Relocation of SR 113 From CR 31 To Richland  
Creek @ Old Alabama Road Relocation – Phase II  
P.I. Nos. 621440 and 621445  
STP00-0179-01(010) and BHF00-0179-01(011)

Value Engineering Study Report

July 2010

AMERICAN ENGINEERS, INC.

R-5A

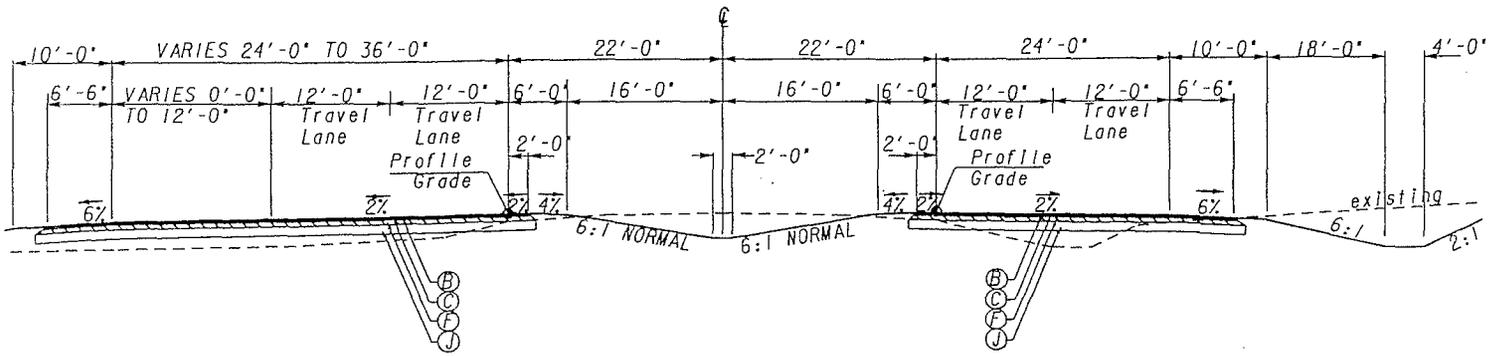
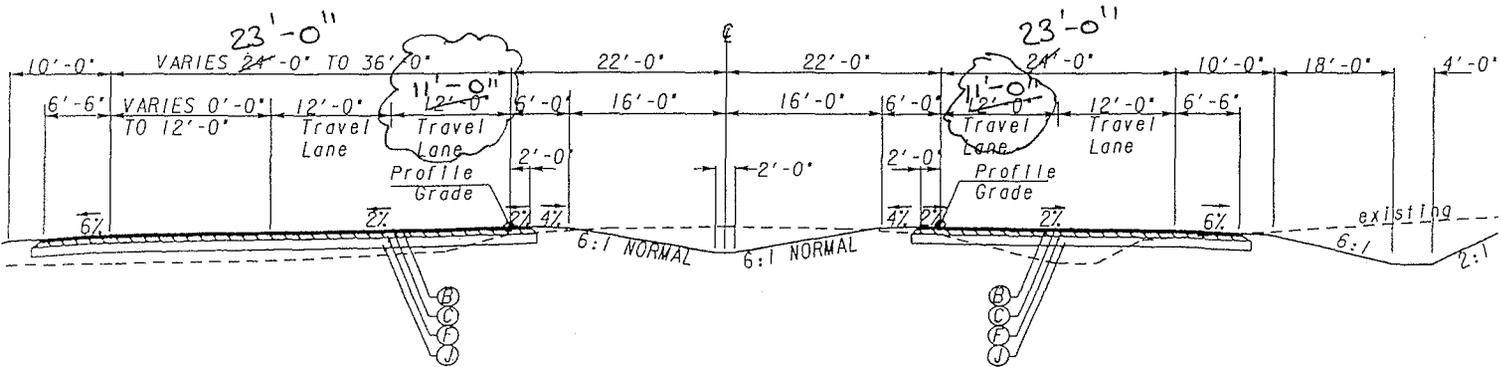
Construct inside lanes 11 ft. wide. Keep outside lanes and turn lanes 12 ft. wide.

AS DESIGNED

ALTERNATIVE

DESCRIPTION: **AT THE CR 20 INTERSECTION WITH SR 113 CHANGE FROM A TYPE B MEDIAN CROSSING TO A TYPE A MEDIAN CROSSING**

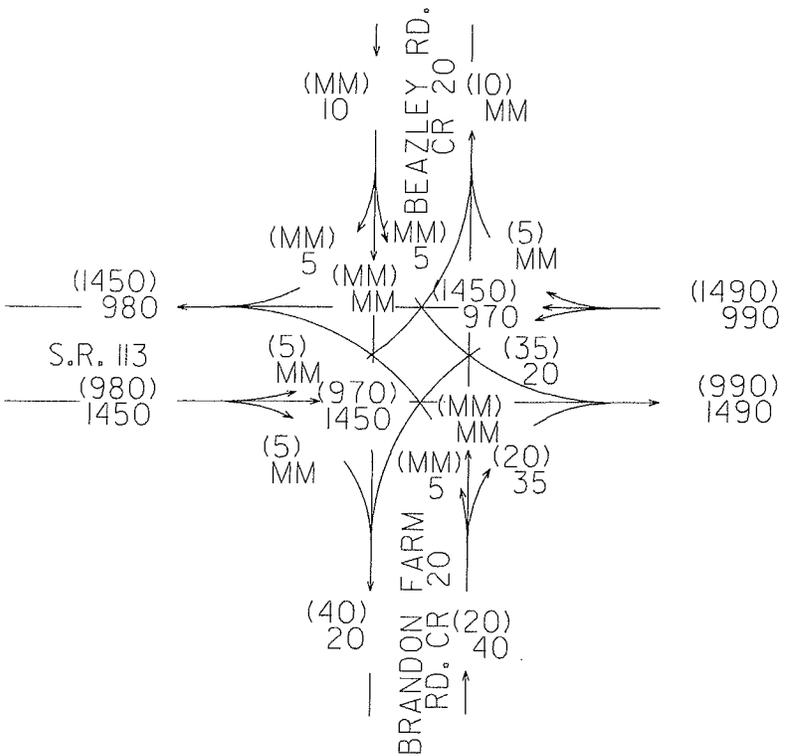
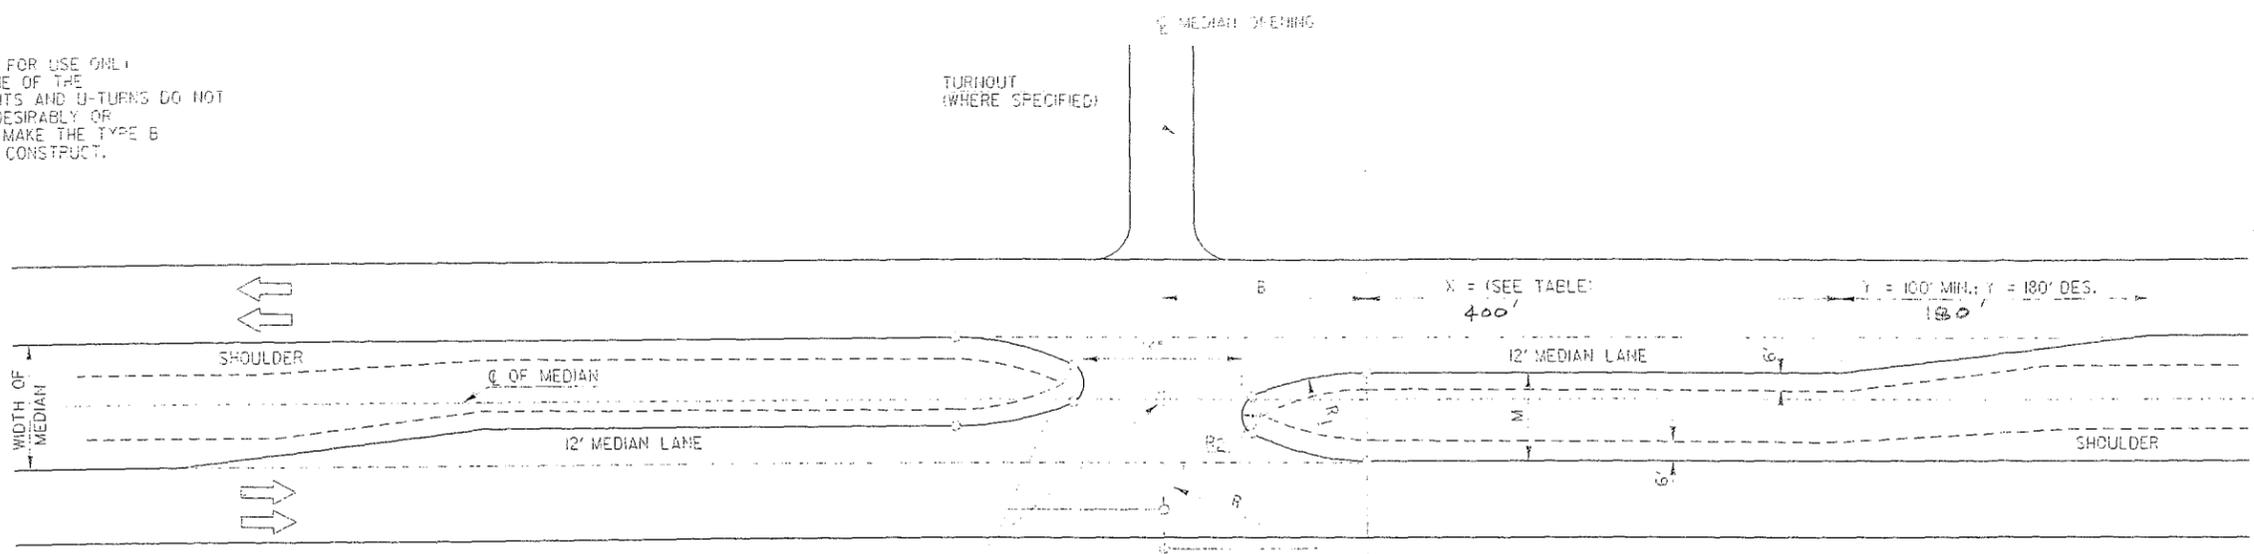
The number of combined left turn movements from SR 113 to CR 20 are 20 vehicles per hour (vph) in the peak AM hour and 40 vph in the peak PM hour in the design year. Although this exceeds the recommended 20 vph in the GDOT standard, this intersection has good visibility from both directions on SR 113 and the intersecting roads are minor roads. Therefore, it is suggested that the Type A median crossing will be adequate in this location and substantial construction and maintenance costs can be saved.

DESCRIPTION: **AT THE CR 25 INTERSECTION WITH SR 113 CHANGE FROM A TYPE B MEDIAN CROSSING TO A TYPE A MEDIAN CROSSING**

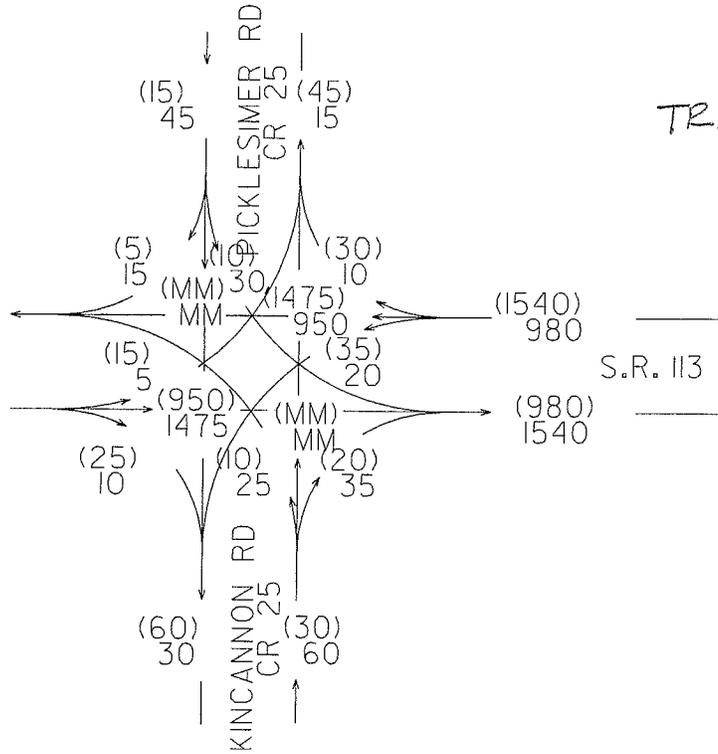
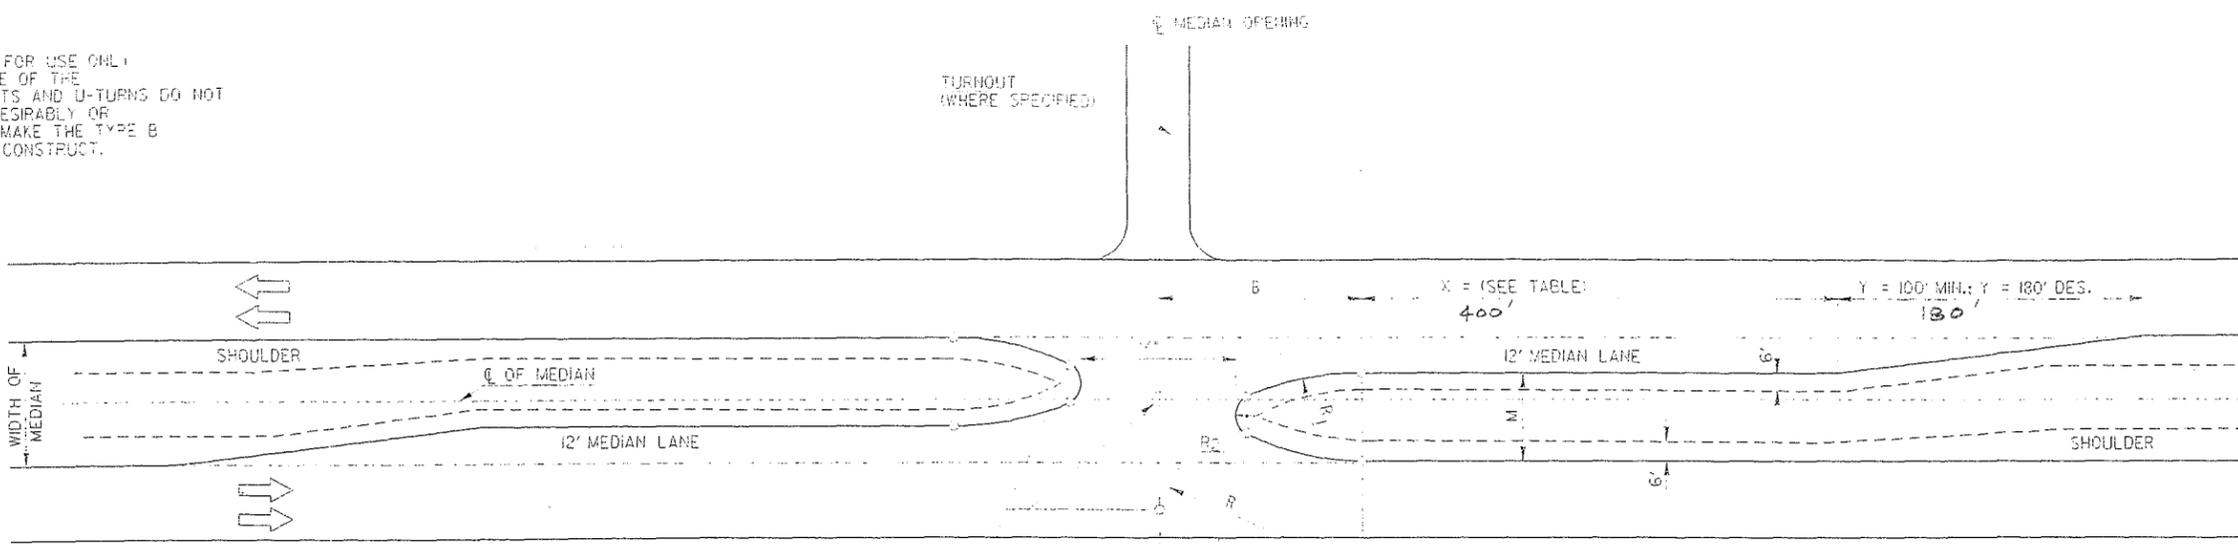
The number of combined left turn movements from SR 113 to CR 25 is 25 vehicles per hour (vph) in the peak AM hour and 50 vph in the peak PM hour in the design year. Although this exceeds the recommended 20 vph in the GDOT standard, this intersection has good visibility from both directions on SR 113 and the intersecting roads are minor roads. Therefore, it is suggested that the Type A median crossing will be adequate in this location and substantial construction and maintenance costs can be saved.

SHEET NO.: 2 of 4

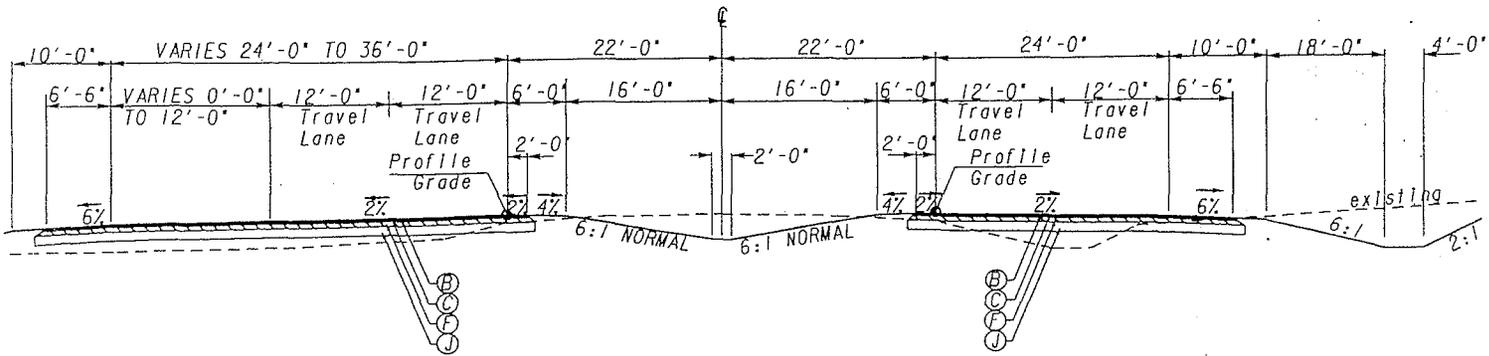
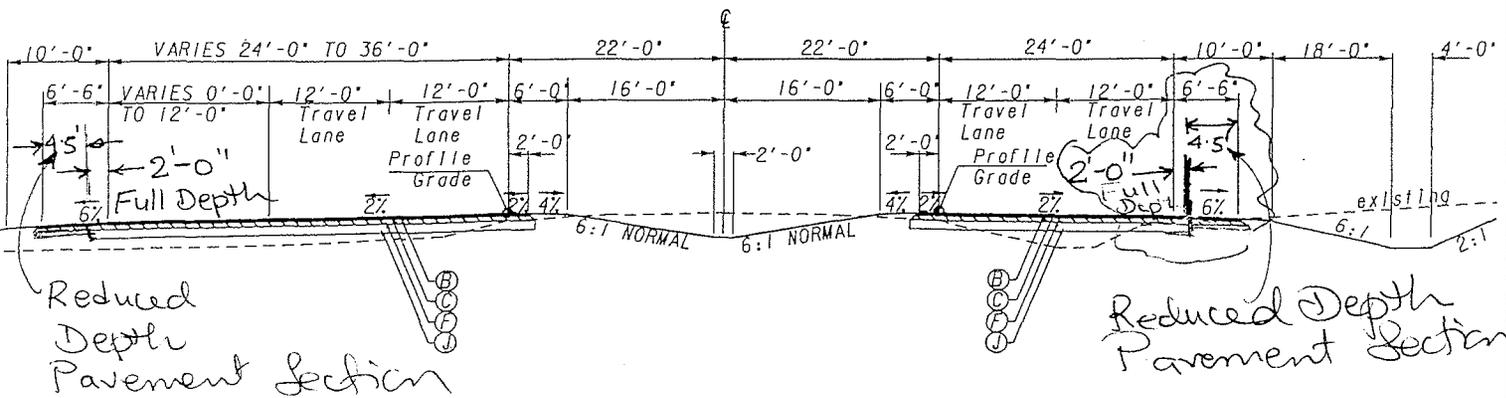
AS DESIGNED  ALTERNATIVE
